MISSISSIPPI POWER & LIGHT COMPANY

SUBJECT: Grand Gulf Nuclear Station
Units 1 and 2
Docket Nos. 50-416 and 50-417
File: 0260/0862
Revisions to FSAR Section 12.5
AECM-82/219

Attached are responses or clarifications pertaining to issues discussed in the Grand Gulf Nuclear Station Final Safety Analysis Report (FSAR). The attachments address revisions to FSAR Section 12.5.

FIGURE 12.5-1
Amendment 57

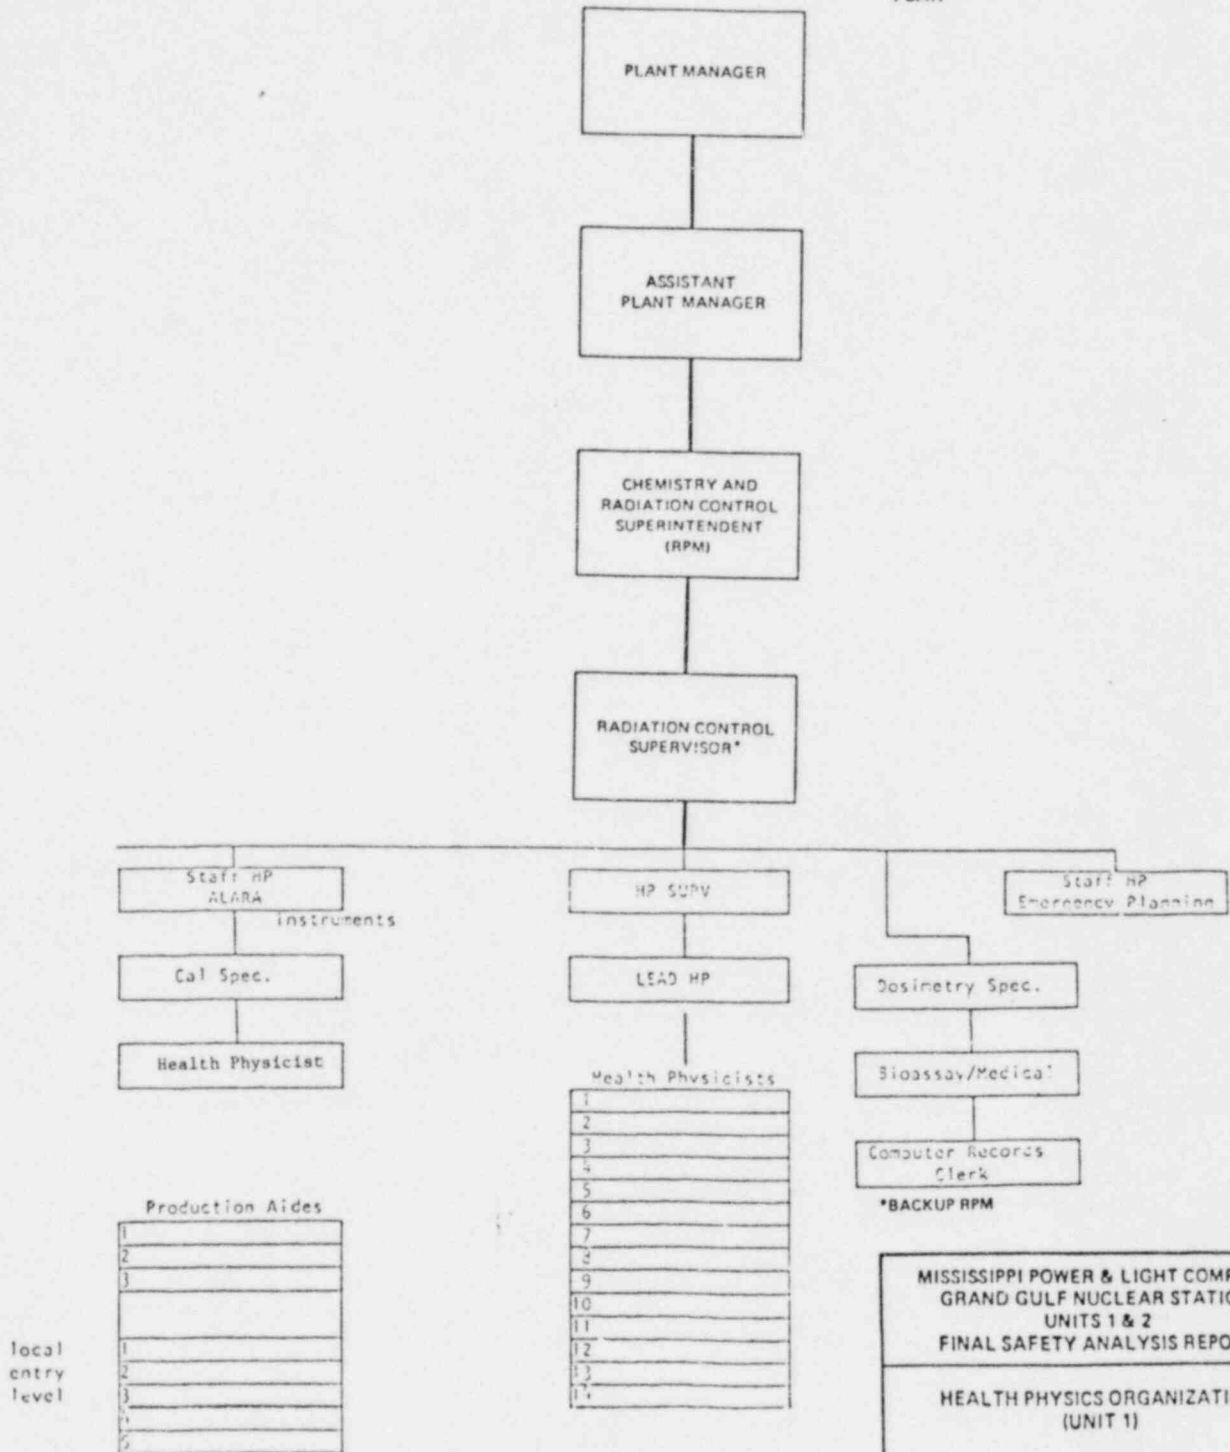
The 19 health physicists implement the health physics program by performing routine and special surveys in accordance with plant radiation protection instructions. This level of staffing will provide adequate radiation protection coverage for plant personnel despite sickness, vacation, or employee attrition.
